Date: 15/8/2017

# To: Al Mabarrat Benevolent Society

# RE: Proposed school, Seventeenth Avenue, Austral-Council concerns

85% of the total school trips from Table- 2 have been distributed at the intersection of Craik Avenue and Seventeenth Avenue applying the distribution pattern shown in Figure-2.

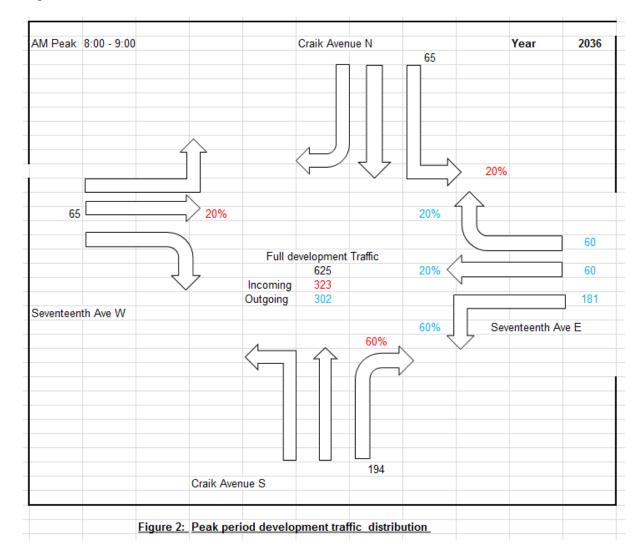
5. **Council concern**: The assumption that about 60% of students will use bus services and 40% of students will be driven to and from school (with a vehicle occupancy rate of 2 per vehicle) is very high and needs to be verified.

A further assessment has been undertaken with a revised modal split, vehicle occupancy rate and development traffic distribution pattern. In the revised assessment it is assumed that 20% of students will use bus services and 80% of students will be driven to and from school. A vehicle occupancy rate of 1.2 has been used. As part of the assessment, the impact of the development traffic at the intersection of Craik Avenue and Seventeenth Avenue has been assessed by way of intersection modeling using SIDRA. All the related background information has been reproduced below along with the revised assumptions and analysis.

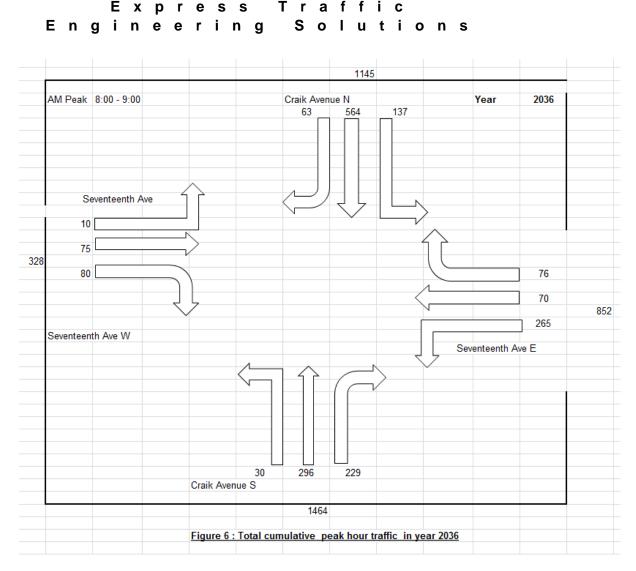
6. **Council concern**: The applicant is to address the provision of a roundabout at the intersection of Seventeenth Avenue and Craik Avenue.

In order to identify the cumulative impact of the proposed development in year 2036, the existing school traffic that have been utilising the intersection of Craik Avenue and Seventeenth Avenue forecasted for current approval of 350 students has been added to the future background precinct traffic and the proposed school development traffic and shown in Figure-6.

The traffic volumes in Figure-6 have been used as input volumes in the microsimulation software 'SIDRA Intersection' in order to test the cumulative impact of the proposed school development. The intersection has been modelled as a 'Give Way' sign controlled intersection.

The results of the analysis show that the worst approach of the intersection is operating at a Level of Service (LoS) of 'D' in the morning peak hour under the estimated traffic volumes in the year 2036. This includes the cumulative traffic of the proposed school development, existing school in Gurner Avenue and the Austral Precinct traffic in the year 2036. Therefore modelling results of the intersection
